SUBSURFACE WASTEWATER DISPOSAL APPLICATION

Town Or Plantation: AUGUSTA

Street Subdivision Lot #: FOREST AVE

Last: TARDIFF First: RICK

SITE PLAN

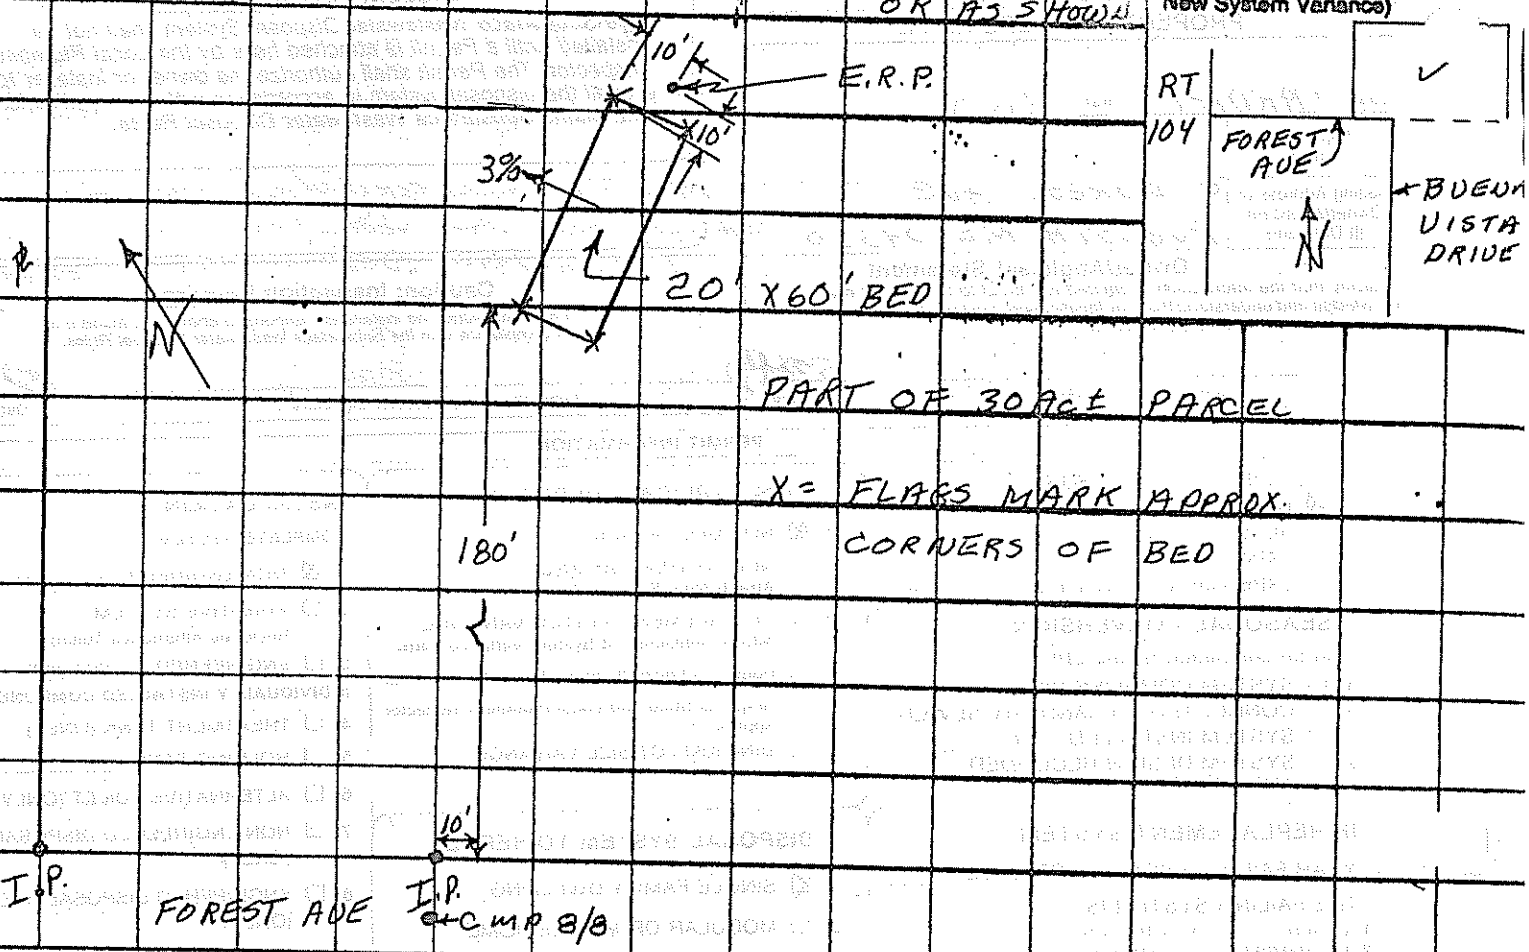
9-10-87 Mr. Redman called and left the message that this system is a few feet out of block, the deviation is OK. and the location is close enough.

9-1-87. Mr. Bonnafont was given a copy of the original septic design to place the septic bed. Mr. Rideout had moved the bed over do to ledge in one corner of the bed. Mr. Tardiff will call Mr. Rideout to see if the bed in its current location is acceptable by his design and have him contact me if so or not.

Geo -
Bill Rideout called
Septic field at Forest Ave.
site that Paul Rodrigue
is building - it's a few
feet out of whack -
the elevation is O.K and
location close enough

9-18-87 Inspection (Final) system here at store & all good location off. Is by old standard design not issued design. See back.
